Access Compliance Report

Public Rights-of-Way (Curb Ramps)

Intersection ID: 51011	Main Street: TREMONT_PLACE_RD	Cross Street: BENDING_BRANCH_RD	Location:	S
ADA ID: 6B63AB3C6D76	Ramp Type: Perp	Initial Pass/Fail: Fail	Overall Compliance: No	Severity Score: 22.5
Codes/Mitigation Info/Possible Solution		Field Measurements/Component Compliance

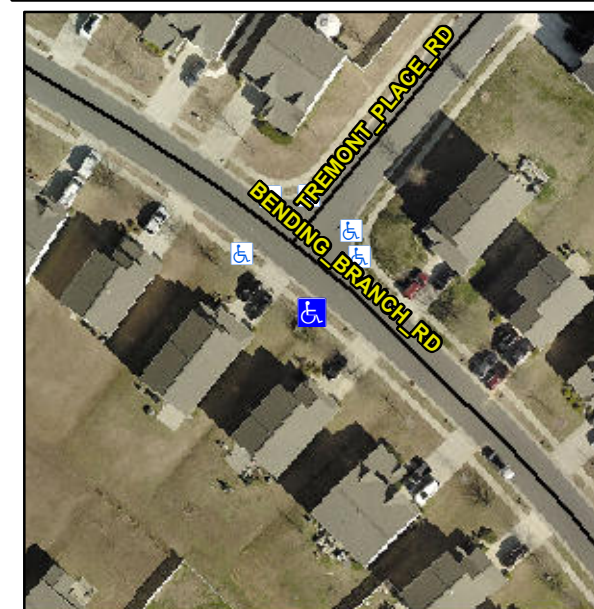
Not Found, R304.5.1, R304.2.2

Compliance	Description	Data	Compliance	Description	Data
N/A	Ramp Length (in)	46.5	No	Ramp Slope (%)	8.4
No	Ramp Width (in)	47.0	Yes	Ramp XSlope (%)	2.9
N/A	Flare Type LT	N/A	N/A	Flare Type RT	N/A
N/A	Flare Slope LT (%)	N/A	N/A	Flare Slope RT (%)	N/A
N/A	Flare Traversable LT?	N/A	N/A	Flare Traversable RT?	N/A
N/A	Landing Length (in)	N/A	N/A	DWS Provided?	N/A
N/A	Landing Width (in)	N/A	N/A	DWS Contrast?	N/A
N/A	Landing Slope (%)	N/A	N/A	DWS Length (in)	N/A
N/A	Landing X Slope (%)	N/A	N/A	DWS Full Width?	N/A
N/A	Landing Curb? (Y/N)	N/A	N/A	DWS Offset (in)	N/A
N/A	Shared Landing?	N/A			
N/A	Gutter Ponding?	N/A	N/A	Gutter Slope (%)	N/A
N/A	Gutter Lip Ht (in)	N/A	N/A	Gutter X Slope (%)	N/A
N/A	Painted X Walk1?	No	N/A	Painted X Walk2?	N/A
	X Walk 1 Direction	To NE		X Walk 2 Direction	N/A
N/A	X Walk 1 Width (in)	N/A	N/A	X Walk 2 Width (in)	N/A
	X Walk 1 Slope (%)	1.7		X Walk 2 Slope (%)	N/A
	X Walk 1 X Slope (%)	3.1		X Walk 2 X Slope (%)	N/A

Remove & Replace Entire Ramp.
